November 4, 2025  
Subject: Demolition of One Building  
State WIN: 025209.10  
Location: Milo  
**Amendment No. 3**

MILO  
 ROUTE 6 BRIDGES  
 GENERAL PLAN I

PLAN

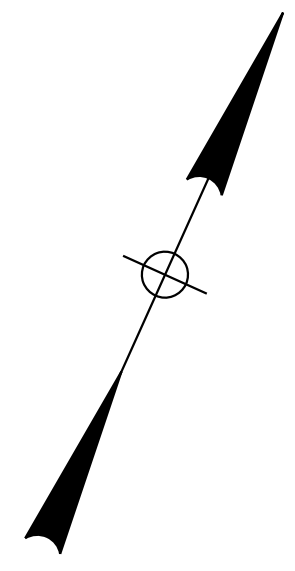
**Question:** Can the concrete foundation be crushed on site and used for backfill?

**Response:** The existing concrete foundation may be used to as backfill material but must be properly processed to meet 703.18 Comon Borrow specifications. The processed product must be free of steel reinforcement and hazardous material and can be placed within the hatched area identified in the attached plan

PROCESSED FOUNDATION BACKFILL ALLOWED WITHIN THIS HATCHED AREA
